# PLANNING COMMISSION REGULAR MEETING

**AGENDA ITEM TITLE:** A. Angelview Planned Development; and  
B. Angelview Major Subdivision

The applicant is requesting Major Impact Review approval for a Planned Development Overlay and Major Subdivision of the remaining lots within the Angelview Minor Subdivision along County Road 120. Land Use Code Sec. 16-3-120 allows for concurrent review of the applications.

Salida Department of Parks and Recreation comments:

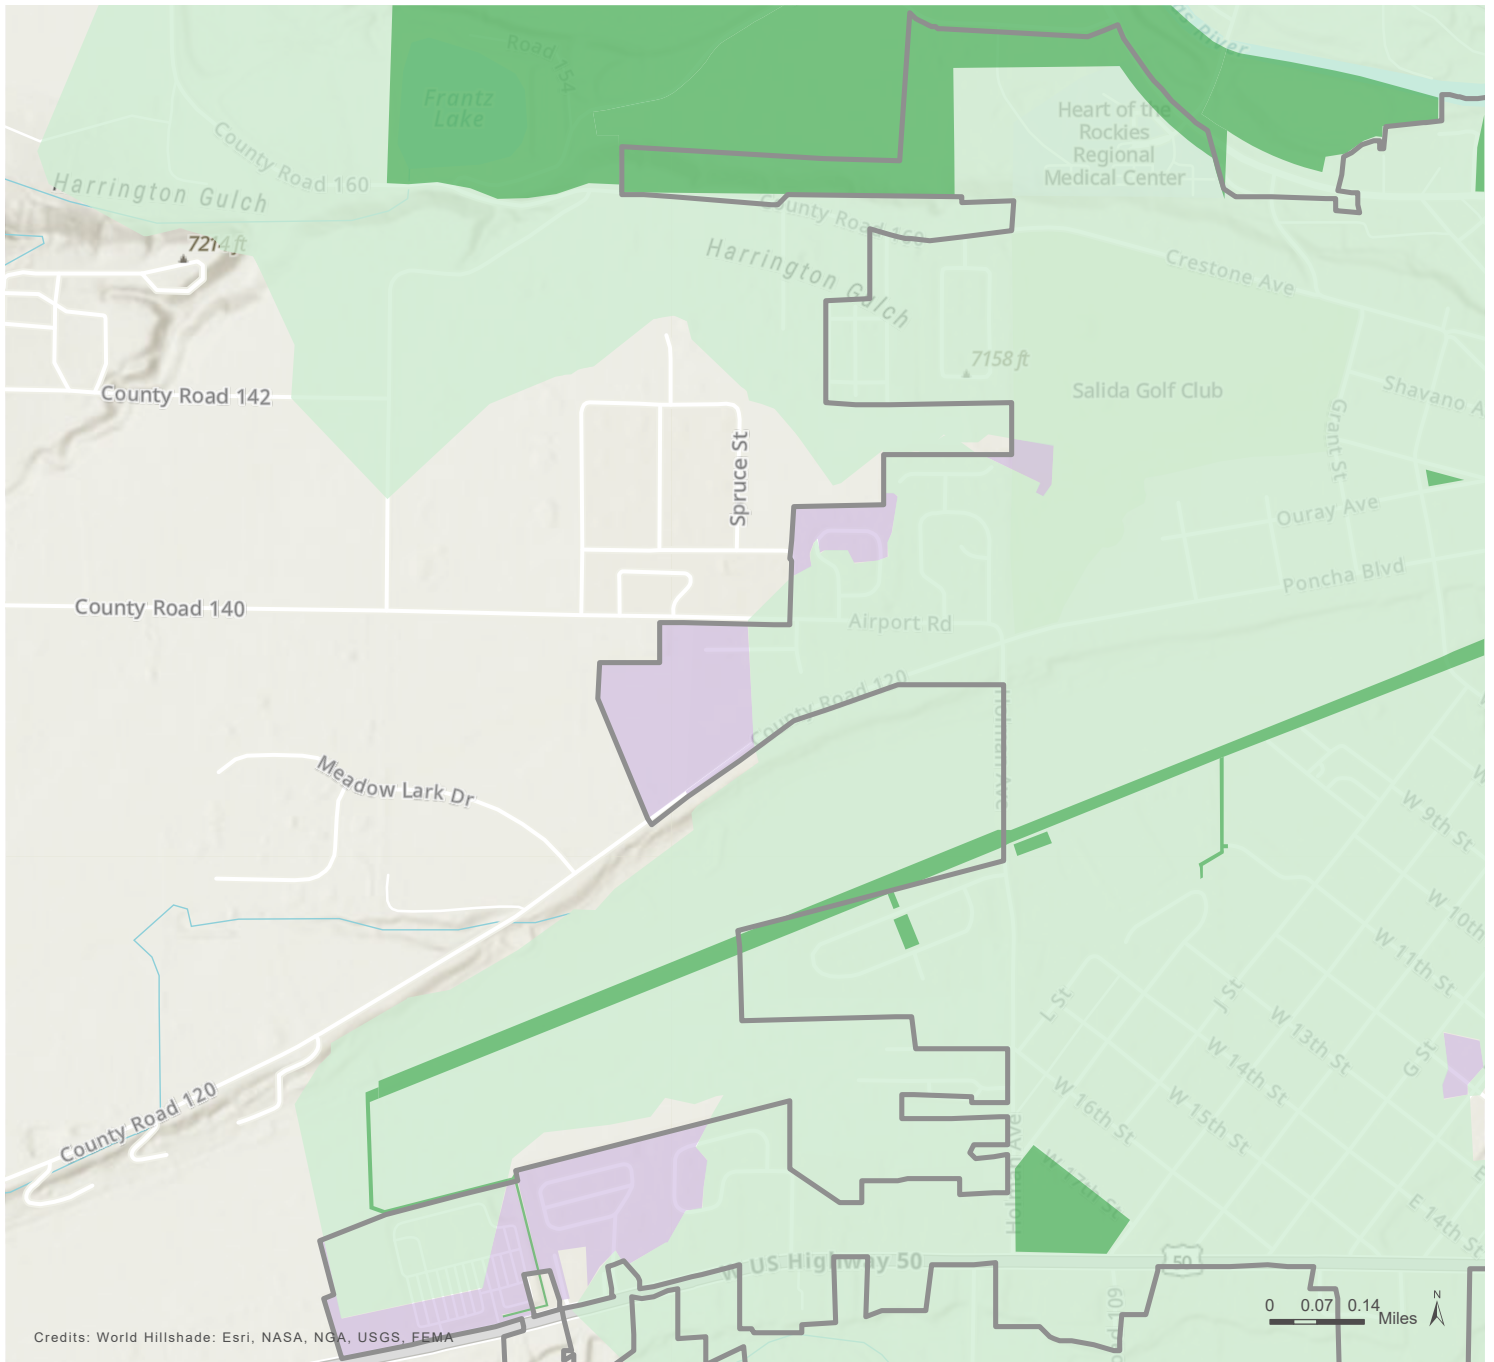
- Section 16-7-40.c.2 states that developers will “dedicate and develop land or pay fee-in-lieu”.
- 115 units = 2.3 acres of Parkland required or \$575,000 of fee-in-lieu (City staff decision)

- Previous negotiations ended with the expectation of 1.5 acres on the Western most edge of the development
- Acceptable city dedication O/S lots or types

- \$276,00 remaining fees for missing O/S due prior to approval of plat
- Please Note: All other lots and paths called out on the *Parks & Open Space* Plan page of the set are unacceptable as dedicated land or land to be considered as parks or open space. “Mid-Block Pedestrian Connections” are not to be considered Open Space.

PUBLIC PARKS AND POCKET PARKS CONNECTED THROUGH A SYSTEM OF SIDEWALKS

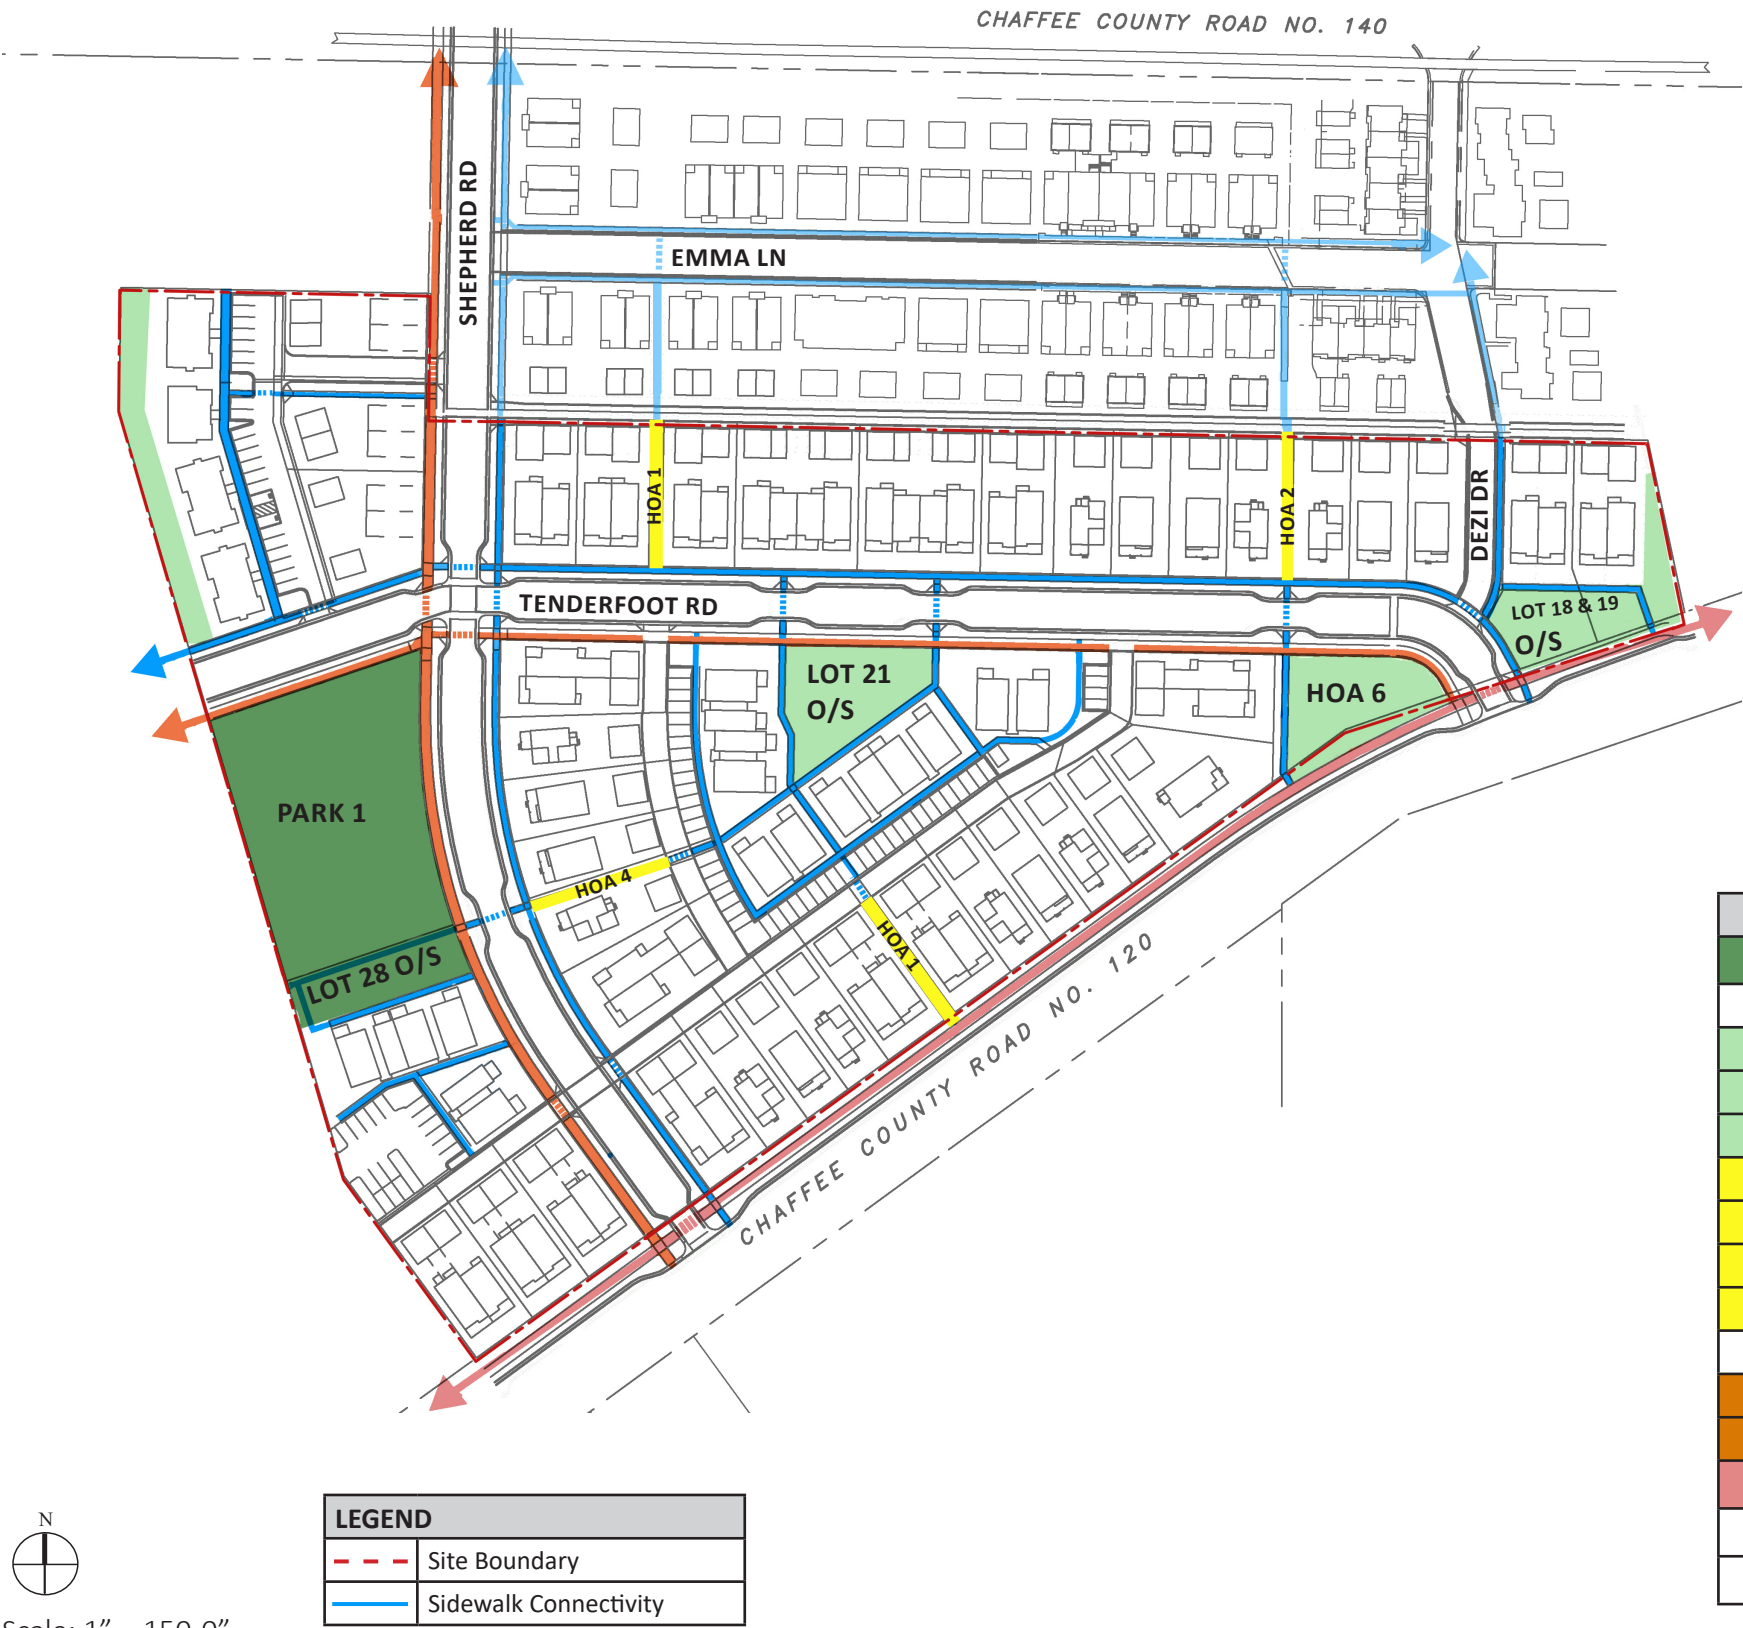
- Please Note: All other lots and paths called out on the Parks & Open Space Plan page of the set are unacceptable as dedicated land or land to be considered as parks or open space. “Mid-Block Pedestrian Connections” are not to be considered Open Space.
